WURLITZER SERVICE SLANTS

SUBJECT: New procedure for Side 1 and Side 2 Readout Switch Actuator Pretravel Adjustment.

EFFECTIVITY: All 3400 Series Phonographs manufactured after the following serial numbers:

Figure 1. Readout Switch Actuator Pretravel Adjustment

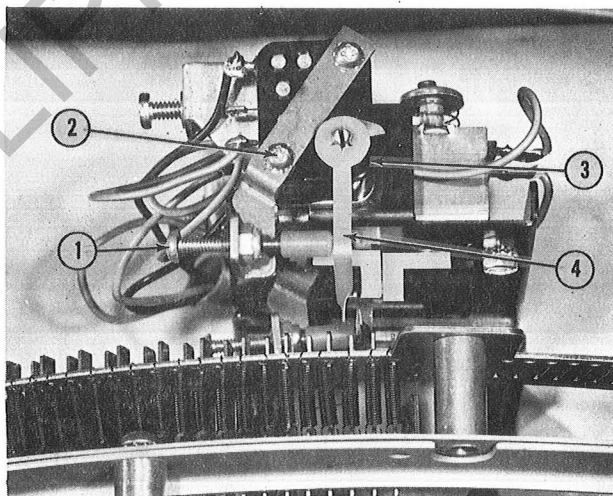
PROCEDURE: To adjust Actuator pretravel on the Side 1 and Side 2 Readout Switches perform the following:

1. Turn Phonograph Volume Control fully counterclockwise.
2. Select A-2.
3. With selected record in play position, turn SIDE 2 PRETRAVEL ADJUSTMENT SCREW clockwise until SIDE 2 RELAY activates (listen for audible click of relay). Refer to Figure 1.

4. Turn SIDE 2 PRETRAVEL ADJUSTMENT SCREW slowly counterclockwise until SIDE 2 RELAY deactivates (listen for audible click of relay), then turn screw one additional full turn counterclockwise .
5. Select A-3.
6. With selected record in play position, turn SIDE 1 PRETRAVEL ADJUSTMENT SCREW clockwise until SIDE 1 RELAY activates (listen for audible click of relay). Refer to Figure 1.
7. Turn SIDE 1 PRETRAVEL ADJUSTMENT SCREW slowly counterclockwise until SIDE 1 RELAY deactivates (listen for audible click of relay), then turn screw one additional full turn counterclockwise .
8. Verify that SIDE 1 and SIDE 2 READOUT SWITCH ACTUATORS do not come to rest over LATCH PIN.
9. Turn Phonograph Volume Control to desired audio level.
